FRUITA PLANNING COMMISSION
REMOTE/VIRTUAL MEETING
May 12, 2020
7:00 P.M.

**Planning & Development Department
Staff Report
May 4, 2020**

Application #: 2020-06
Project Name: Lithic Arts Building
Application: Site Design Review with Adjustments
Property Owner: RDC Labs, LLC
Representative: Hummel Architecture
Location: 158 S. Park Square
Zone: Downtown Mixed Use (DMU)
Request: This is a request for approval of exterior modifications of the existing metal building.

Planning & Development Department
Review Comments – Round 1
April 24, 2020

1 NORTH ELEVATION
A102 NOT TO SCALE

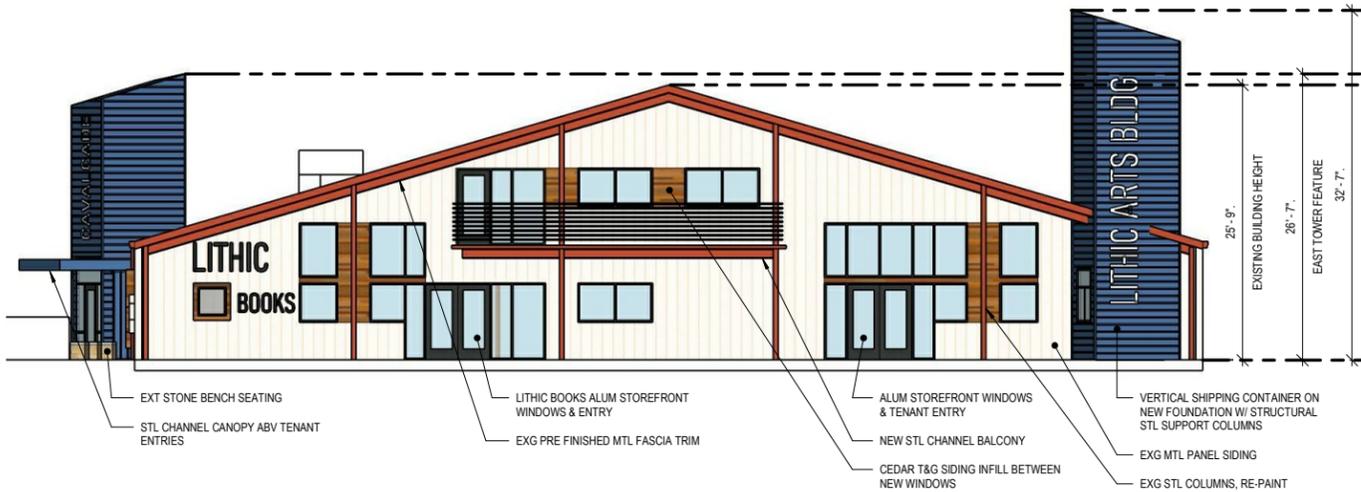
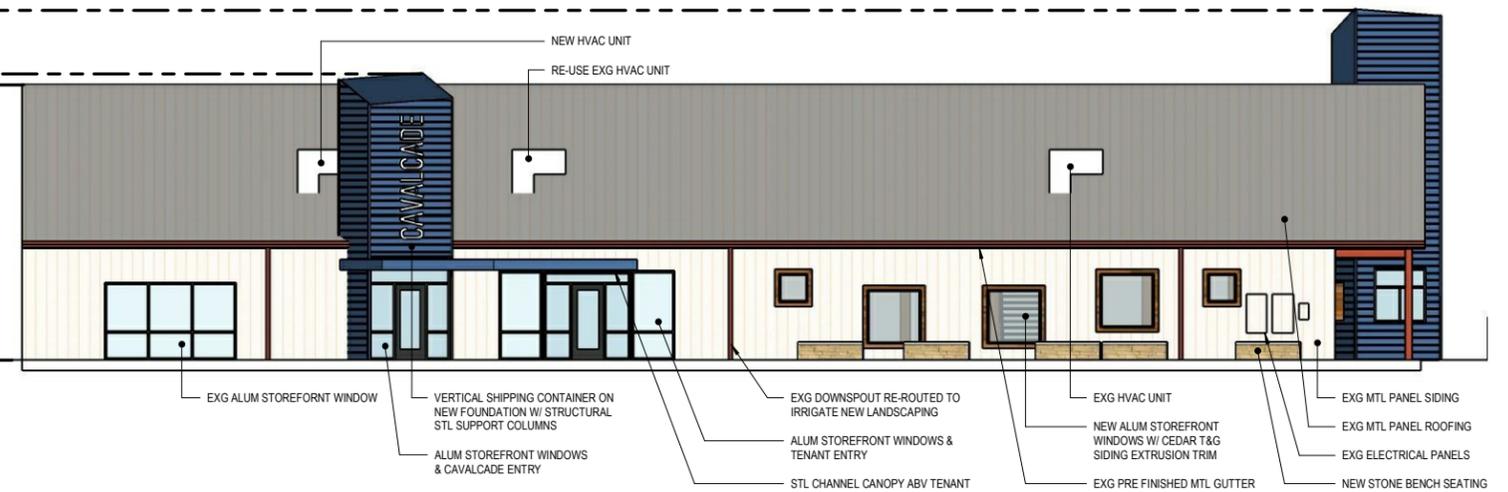
- i. Its Staffs assumption, based on the submittal, that the north tower will contain the name of the building on it. Please confirm if this is the plan. If so, the Code considers this as exempt from the Sign Code and wouldn’t need a permit.

2. Section 17.11.030 (B) (3) (a) states that architectural designs shall address all four sides of a building in the DMU zone. There is opportunity for additional development to the south of the building. Please provide elevations for the south and west.

- a. Staff understands there is a potential for a tenet on the west side. Is the plan to have similar architectural features on this side once a tenet has moved in?

- ii. CA – Correct. The design intent is to apply either stamped metal lettering on stand-offs or contrasting paint colored building name lettering on the north tower.
